9th December 2000

From: John Delderfield

SPIRE HARNESSING, etc.

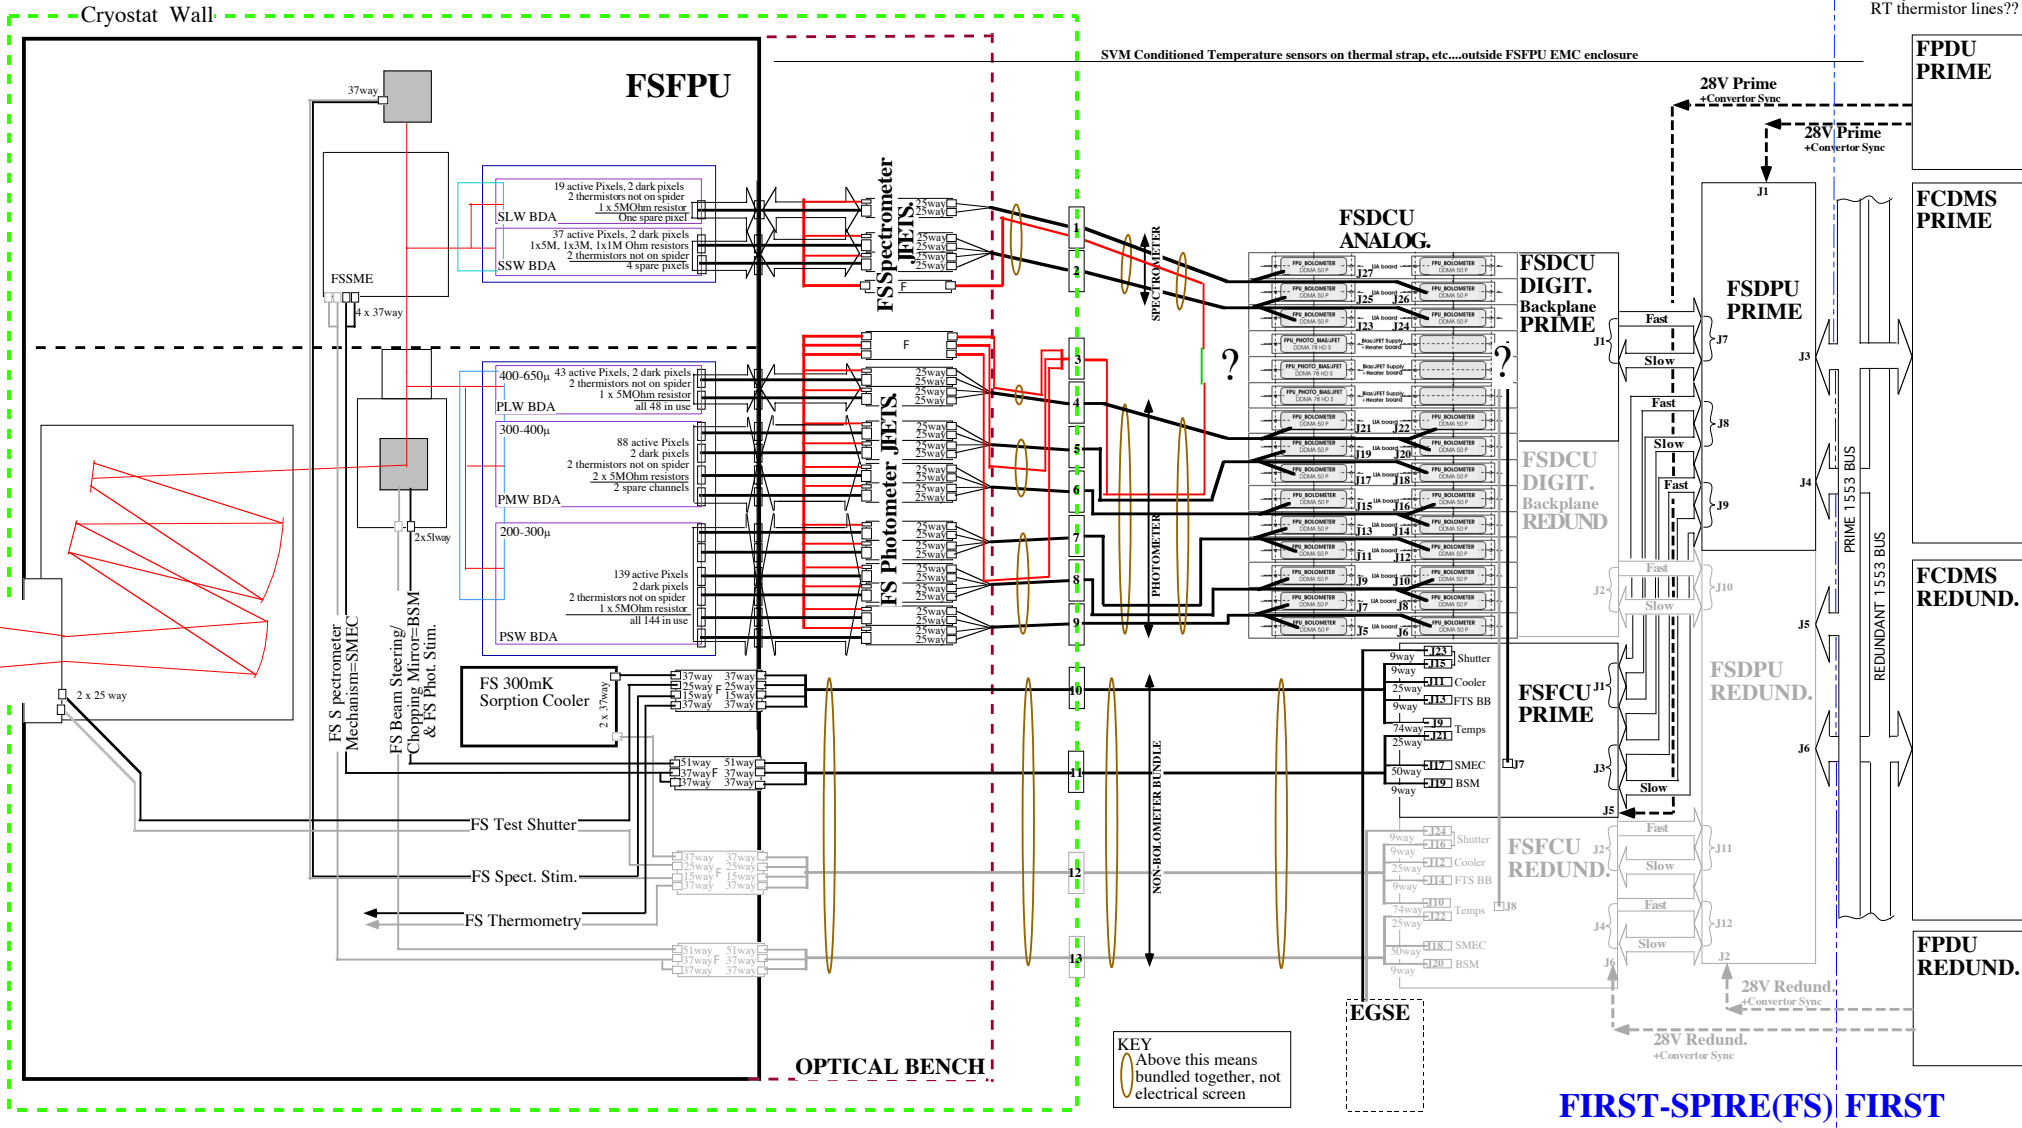
Please find a block diagram of SPIRE. This has been updated to reflect information from the recent reviews. It's best printed in at least A3 colour. This note primarily concerns the non-bolometer systems, but you will note some information missing in the block diagram for photometer bias, JFET supply, JFET heater and JFET temperature areas. I was part-way through generating a comprehensive note on the bolometer systems' design details when I decided it would be best to break off and sort out these more straightforward areas.

12th December Corrections: Pixel numbers in block diagram adjusted to take account of Jamie's comments a while back...should have done anyway but omitted, sorry.
